INSTRUCTIONS FOR REPLACING A FRANKLIN MODEL 6A8-215-B8F ENGINE
(SERIAL NOS. 23001 TO 23500 INCL.) WITH A FRANKLIN MODEL
6A8-215-B9F ENGINE (SERIAL NOS. 23501 AND UP) ON A SEABEE

The following modifications must be accomplished on the Seabee when replacing a Franklin Model 6A8-215-B8F Engine serial Nos. 23001 to 23500 incl, with a Franklin Model 6A8-215-B9F Engine serial Nos. 23501 and up. All necessary parts are furnished with the engine in a kit. This kit is Republic spare part item 1531.

FIG. 2 INSTRUCTION No. 11, Page 2

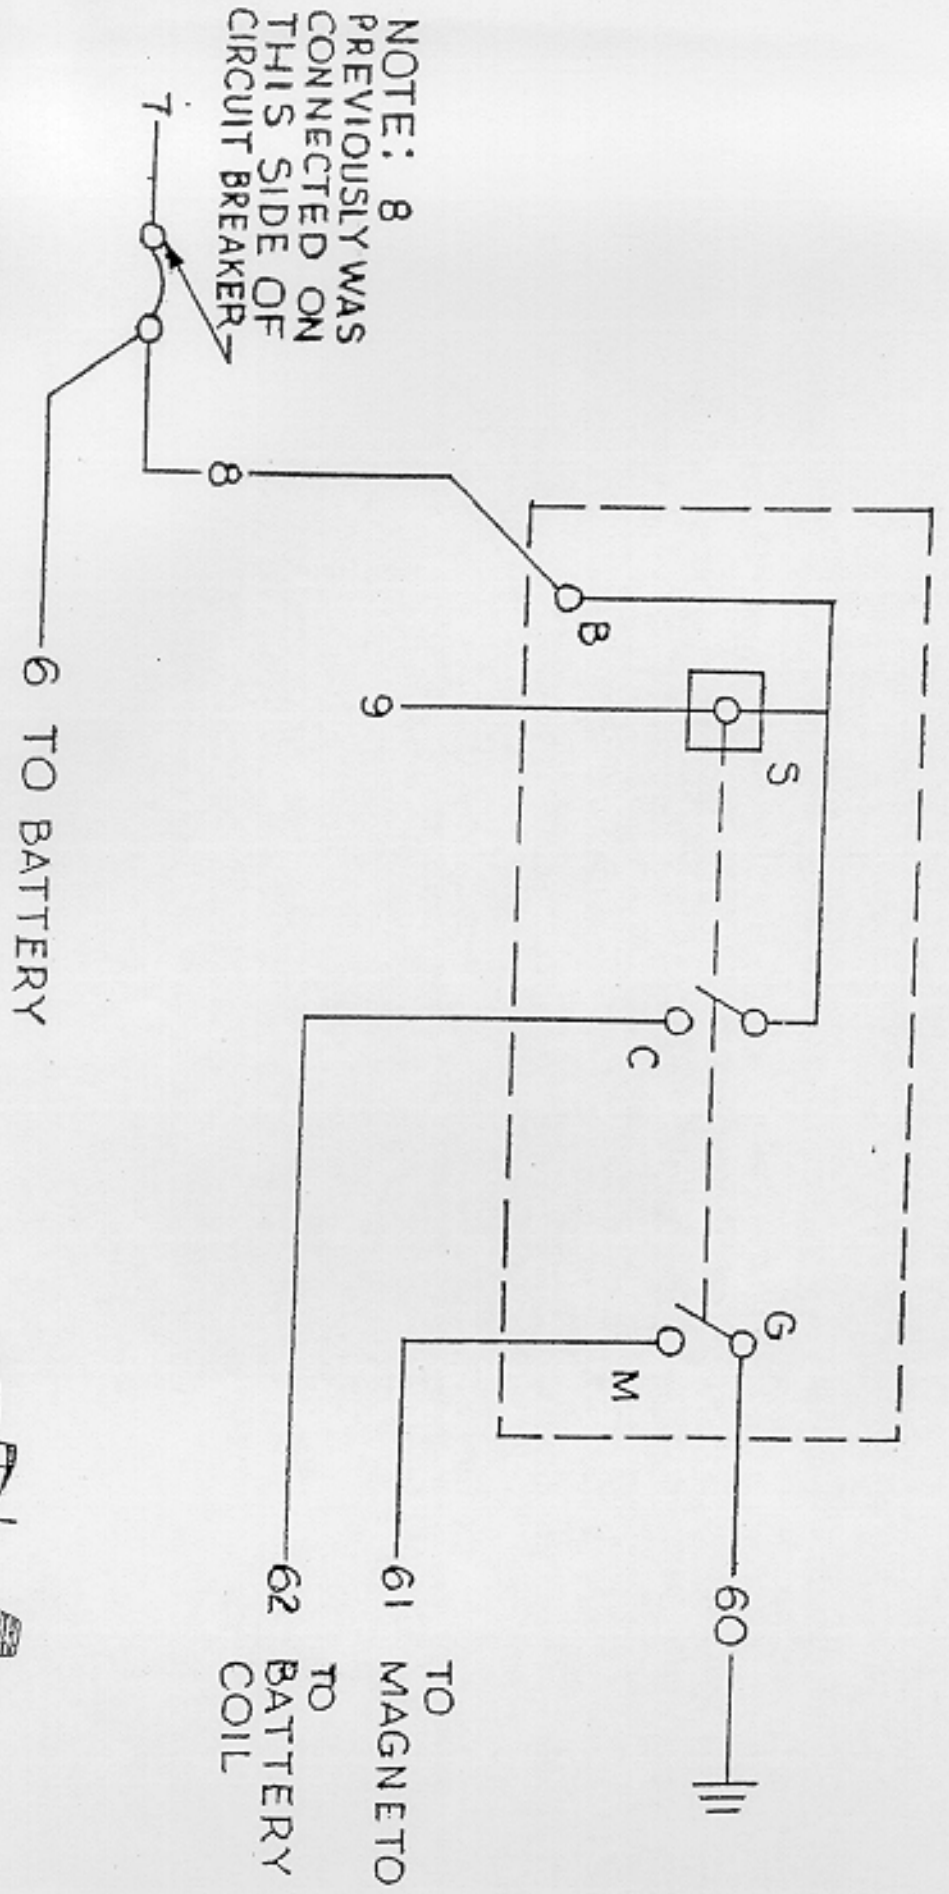
3. The ignition switch must be replaced with the new type furnished in the kit and this is to be wired as shown on figure 2. When installing this switch also replace the placard with the new one furnished. Please note the relocation of wire No. 8 on the circuit breaker as shown on the wiring diagram.
